Addendum No. Four

Date: April 11, 2022  
Project: Hinesville City – Taylors Creek, SE No. 2017-100  
Engineer: Simonton Engineering, LLC.  
Greensboro & Hinesville, Georgia

**Non-Potable Reuse Line Extension & 4.0 MGD Discharge Relocation to Taylors Creek**  
**Bid Items Amended 4-11-22**  
**SE No. 2017-100**  
**Contract One**

Plan & Profile  
 DATE: JUNE 9, 2020  
 FILE NO: 2017-100PRJ  
 SHEET: 2

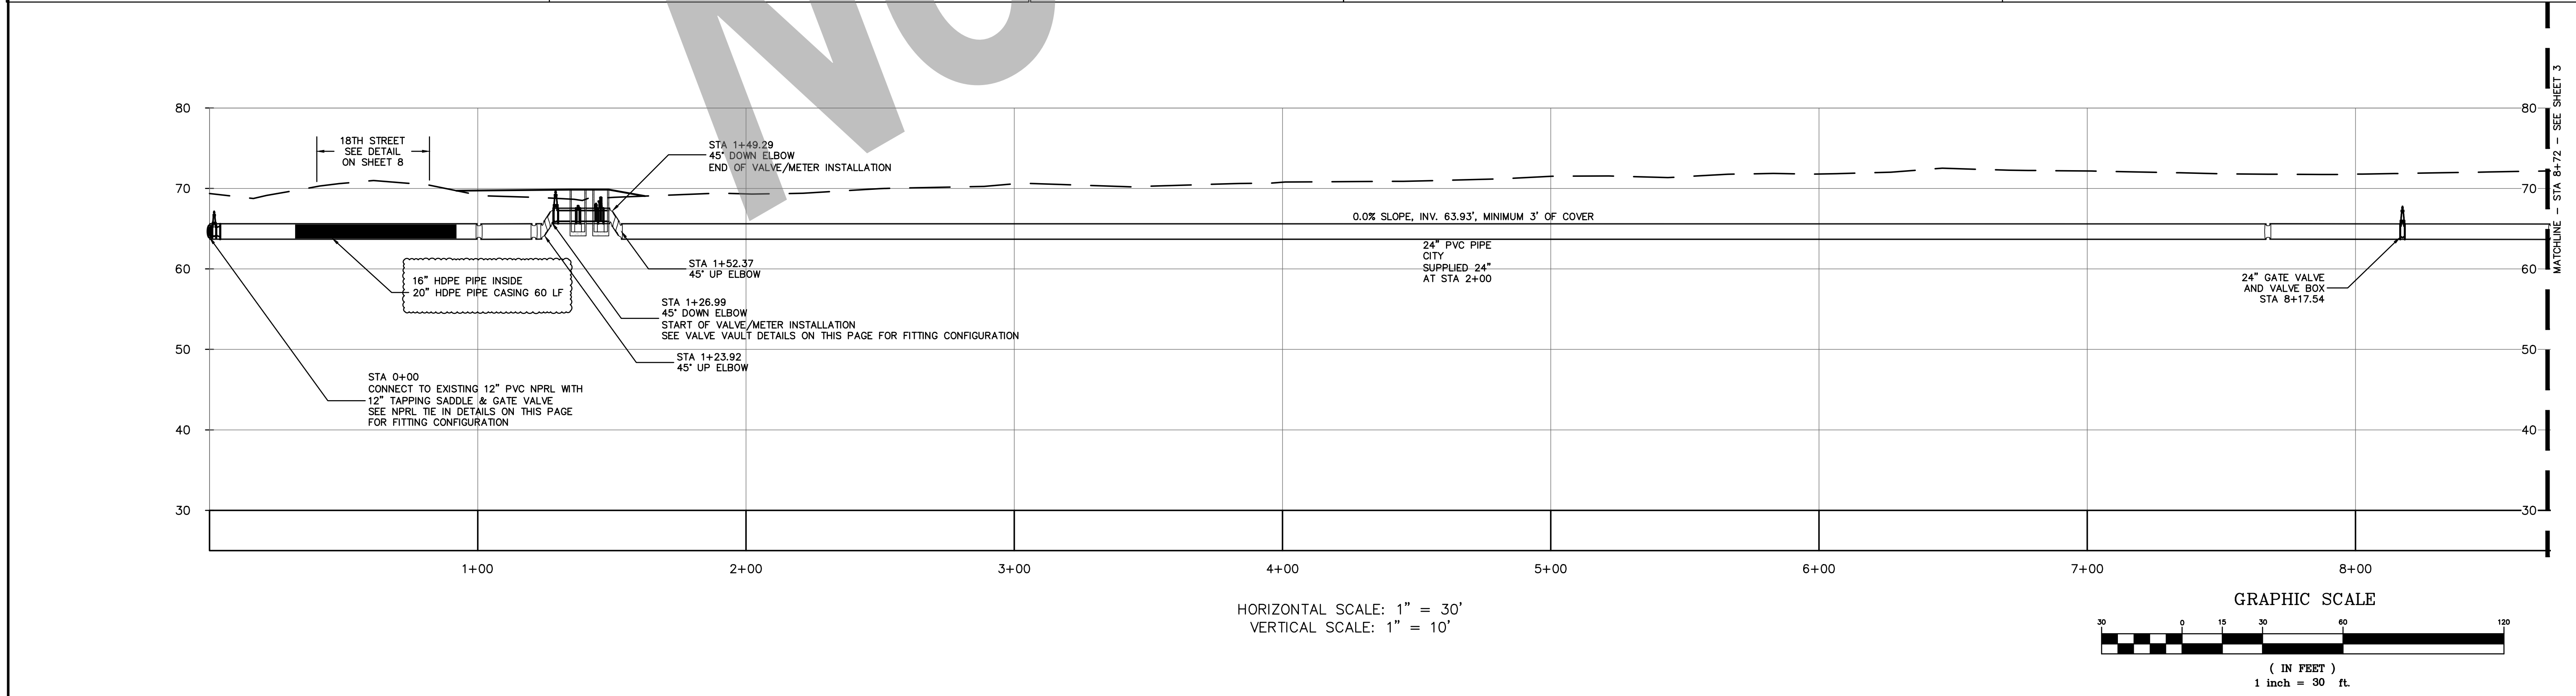
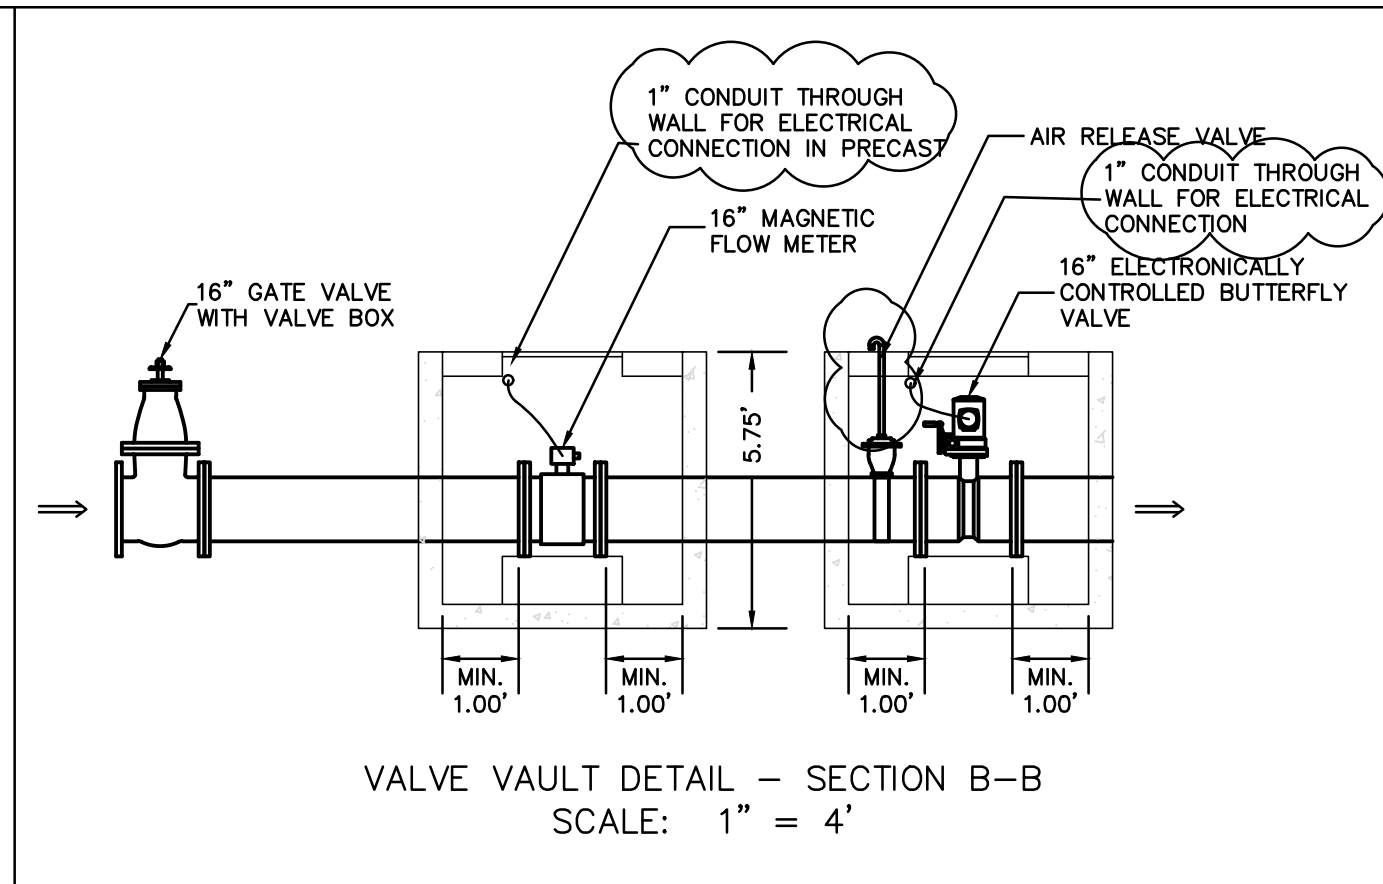
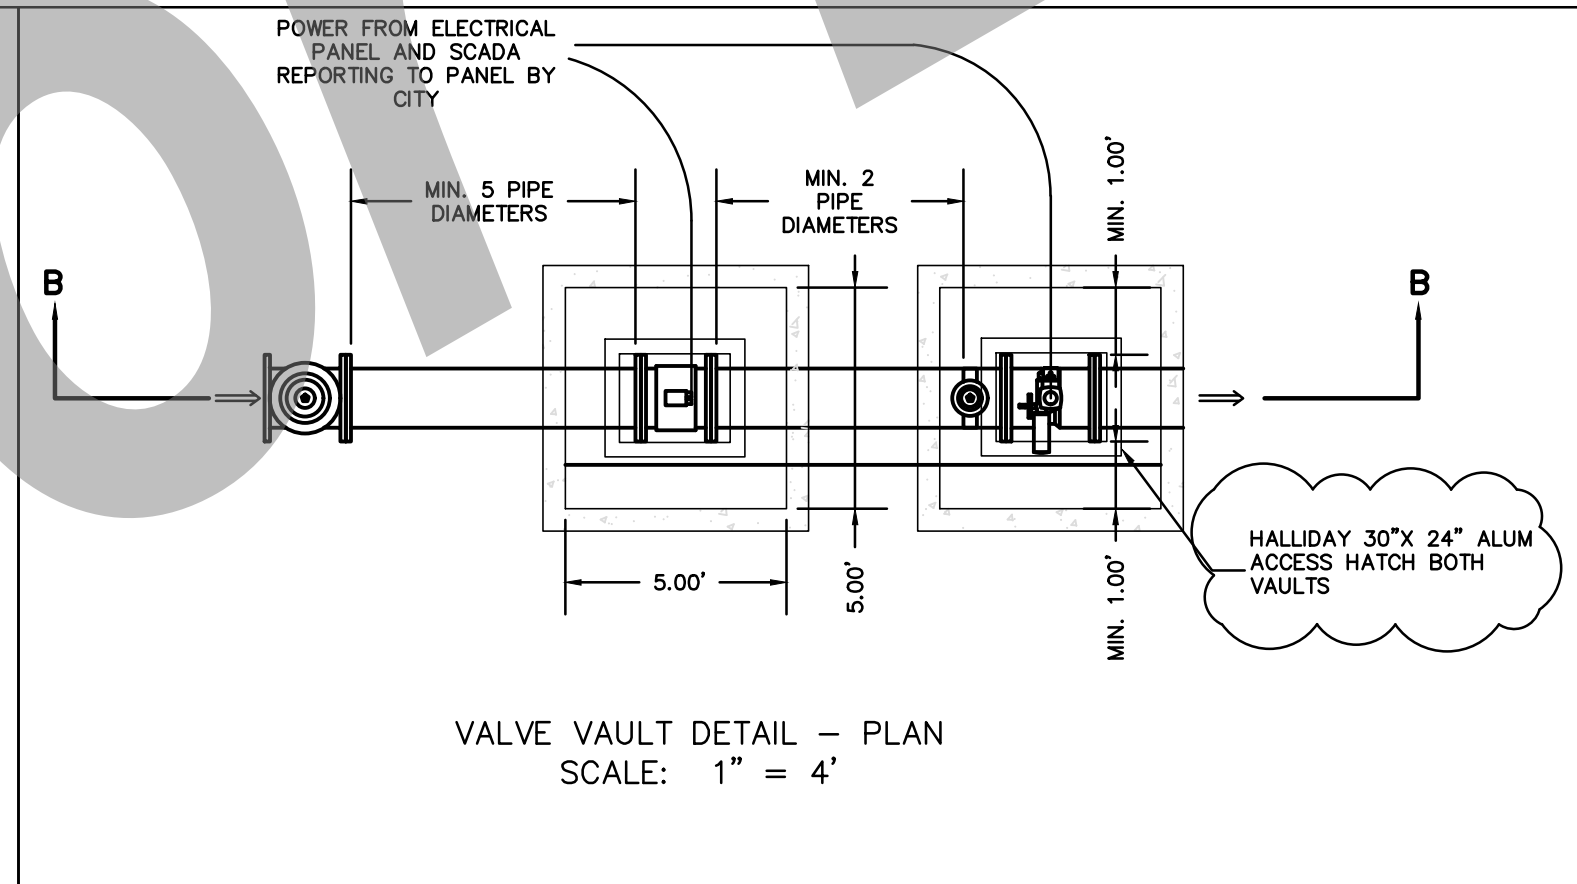
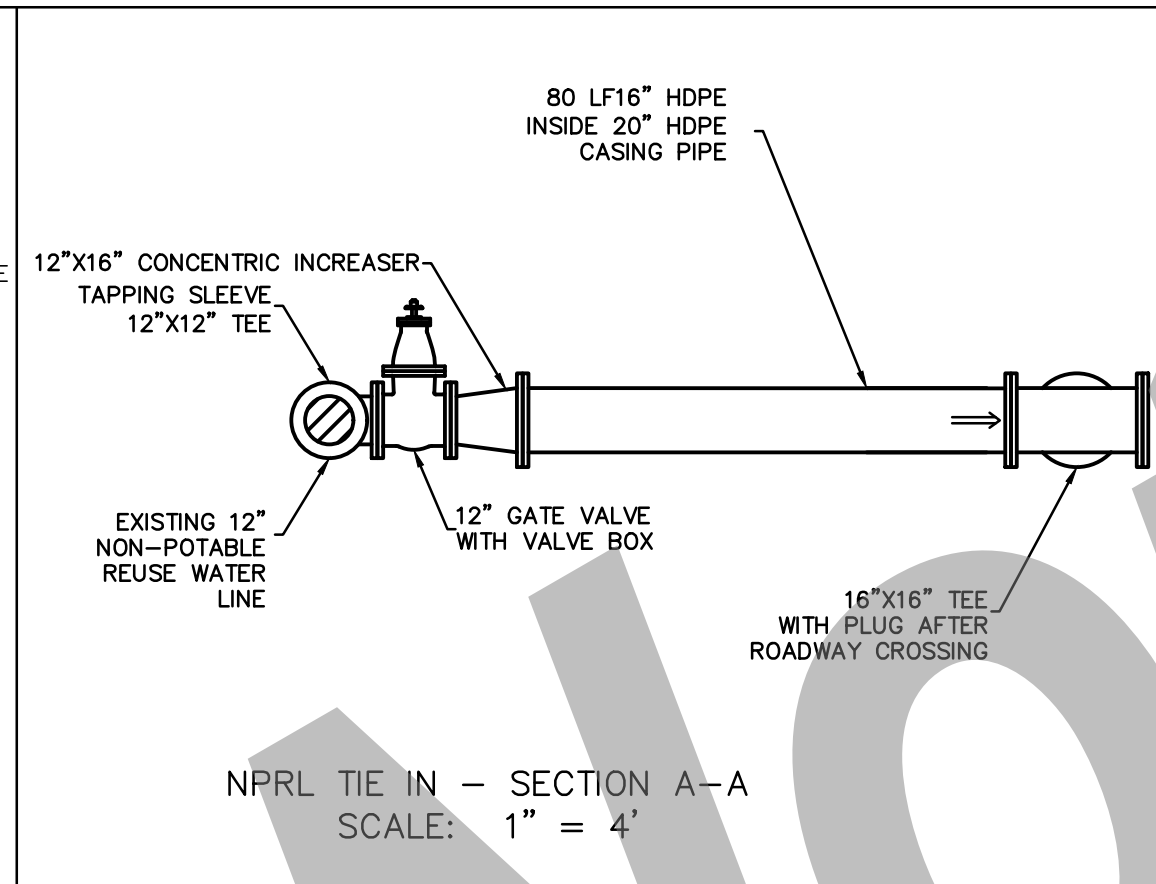
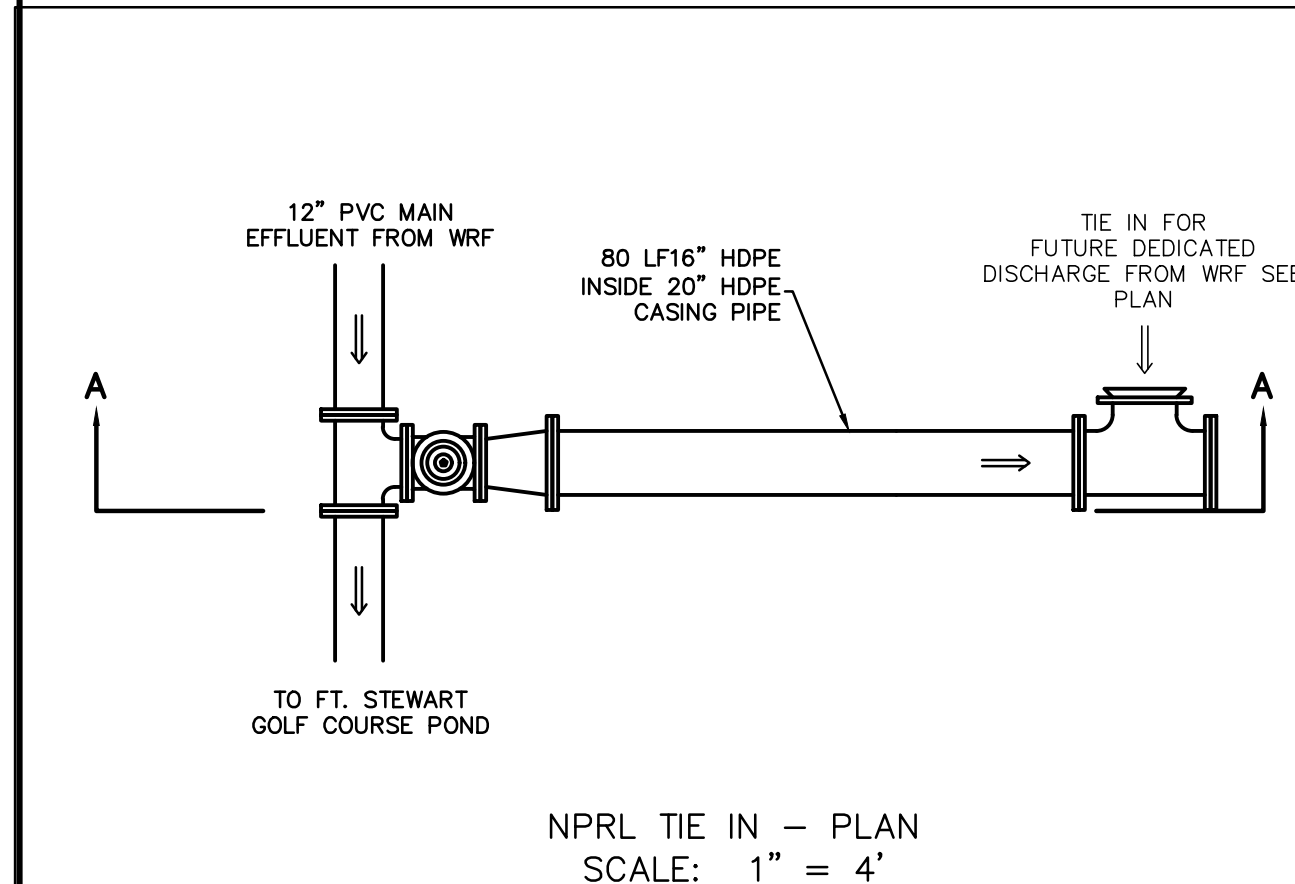
- All sheets – Replace “Fusible PVC Pipe” labels with “HDPE Pipe” label.
- Sheet 2 – Replace sheet 2 with the enclosed Sheet 2. NOTE CLOUDED modifications related to valve vaults and pipe type.
- Sheet 8 – Replace the work description on sheet 8 with the paragraph below:
